ADDENDUM NO. 2

RFP #22-53

Valve and Finished Water Tank & Reservoir Improvements

SCHEDULE C - PROCESS IMPROVEMENTS
STRUCTURAL FLUORIDE FACILITY
PLAN, SECTIONS AND DETAIL

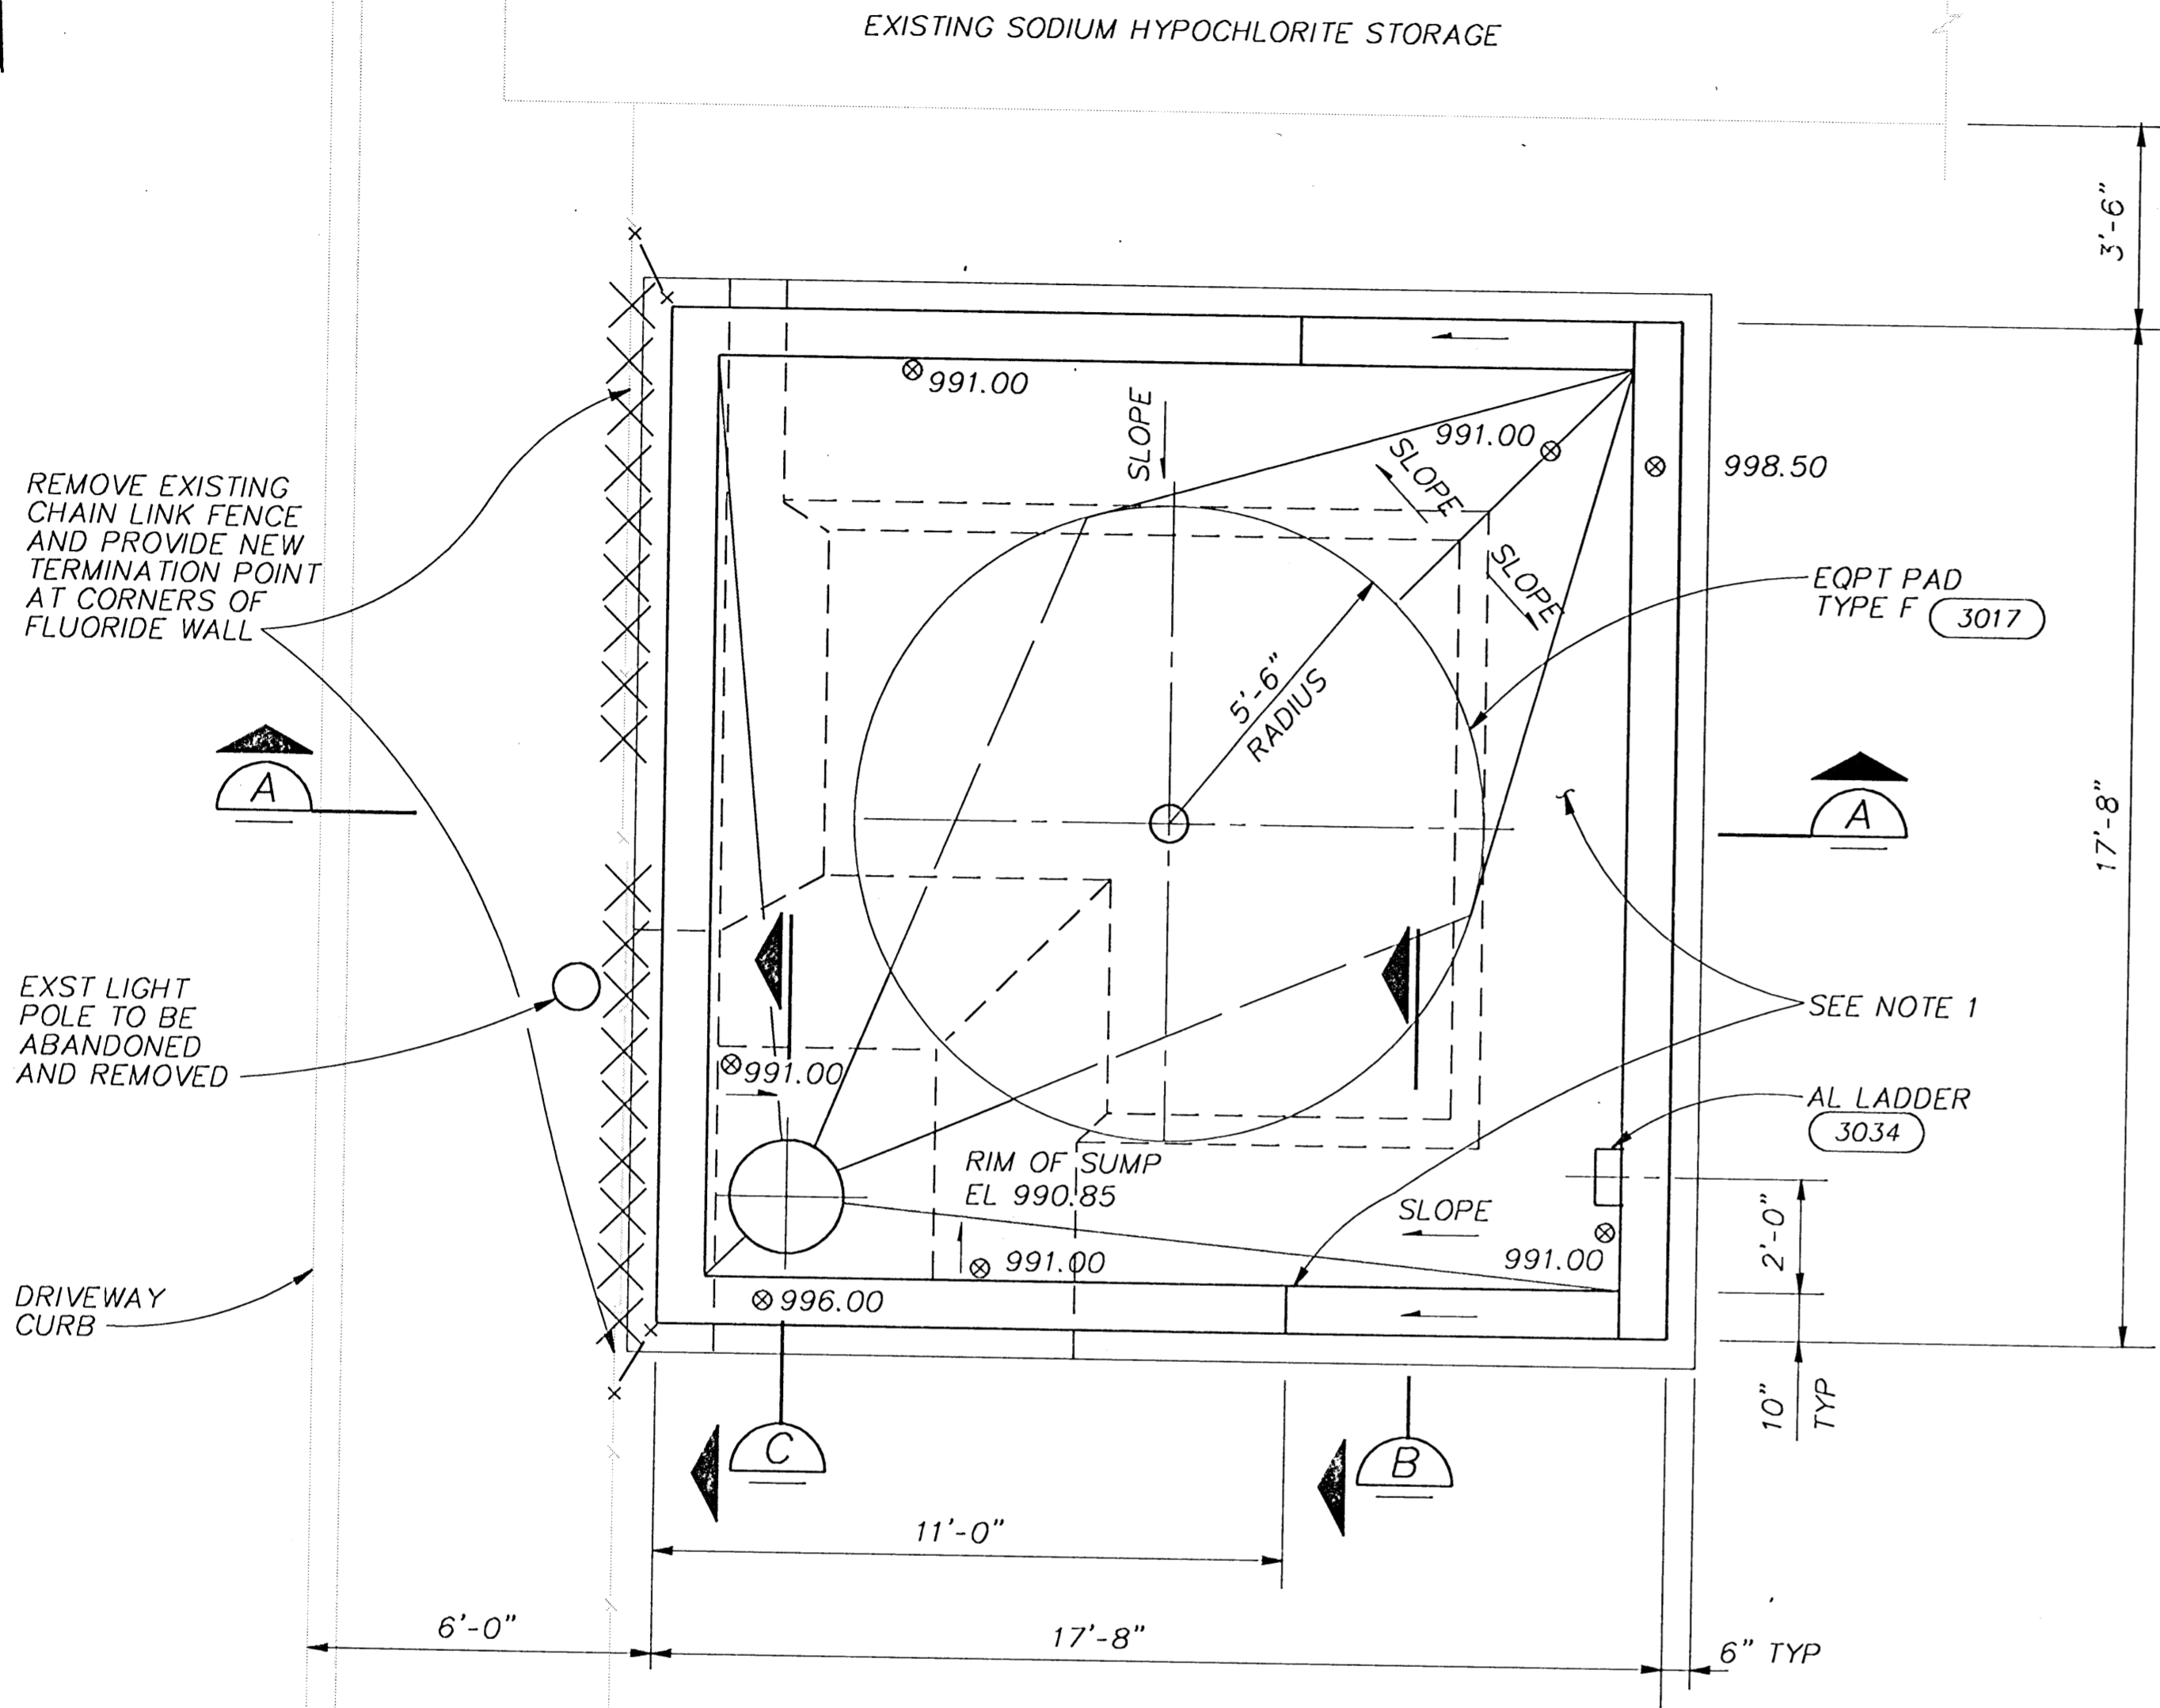
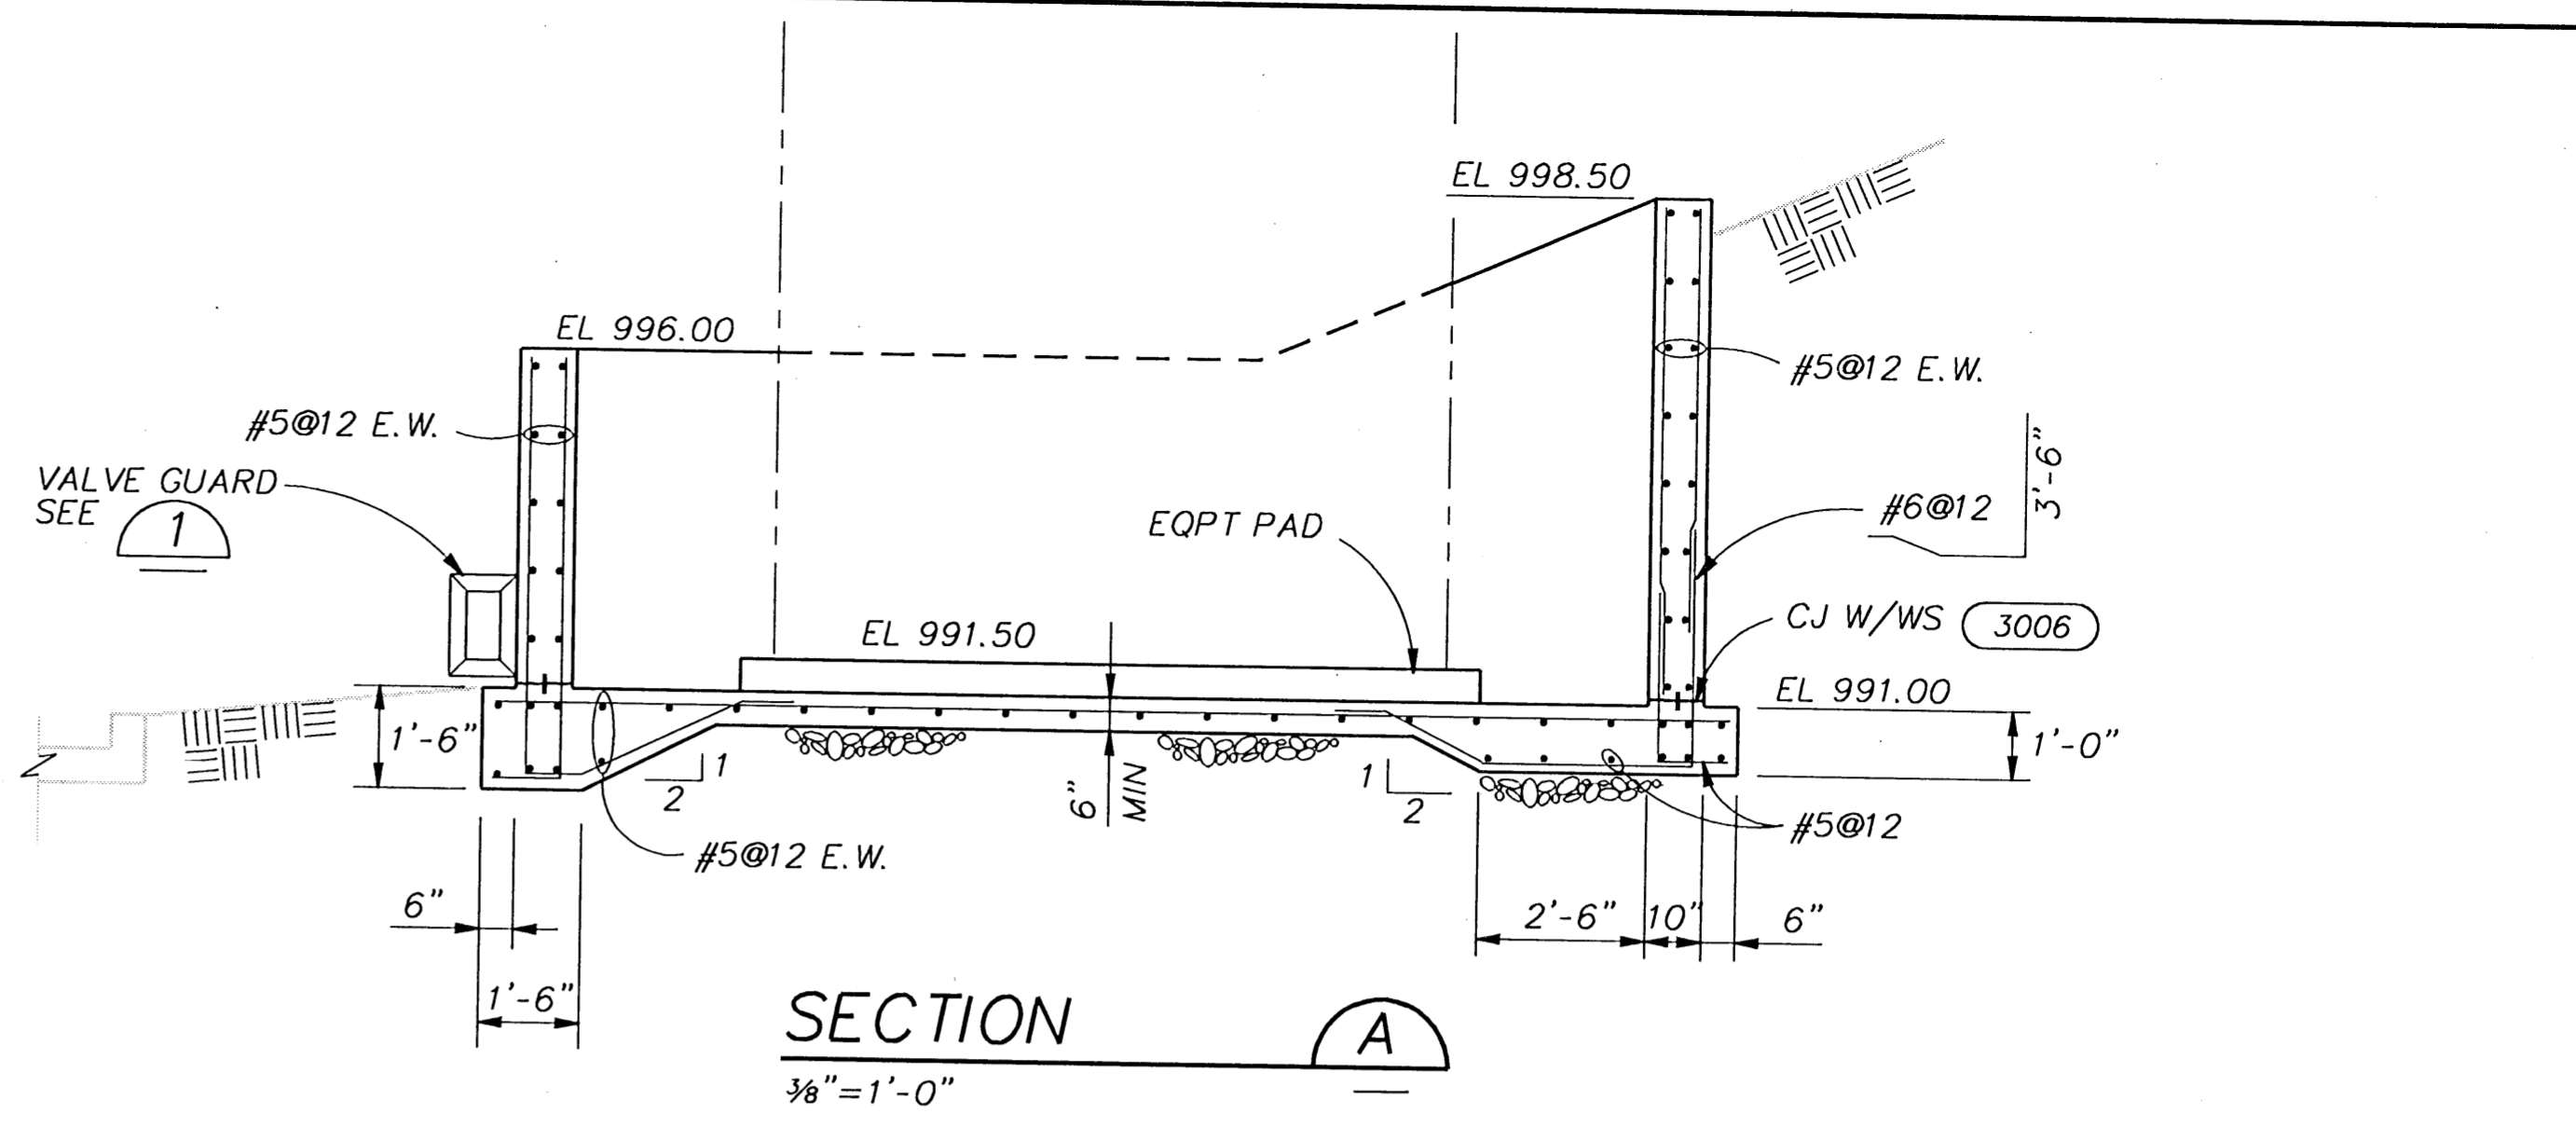
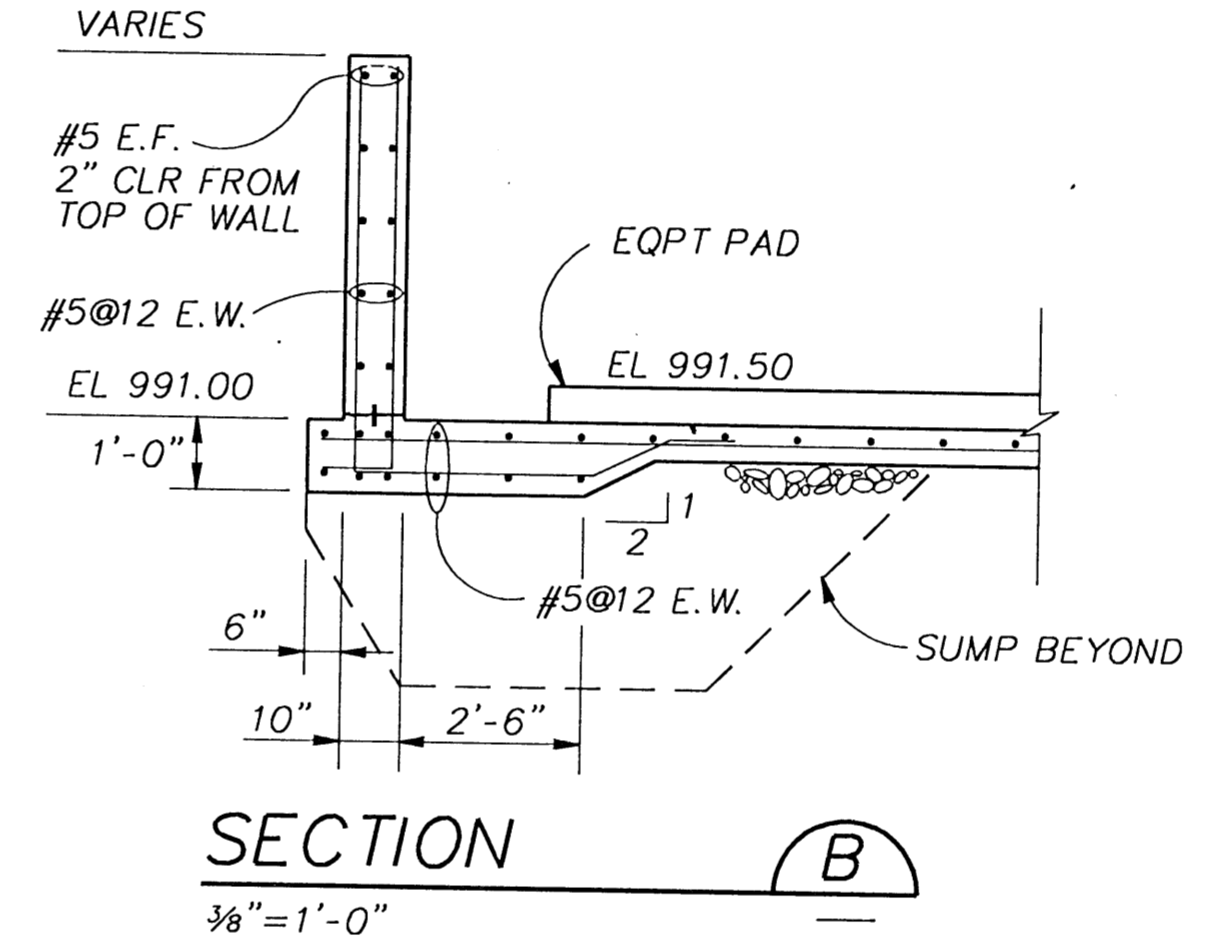
- Q: What is the bottom of foundation elevation for the fluoride bulk tank located immediately NW of vault 3 shown on drawing No. 9?
- A: See attached record drawings.
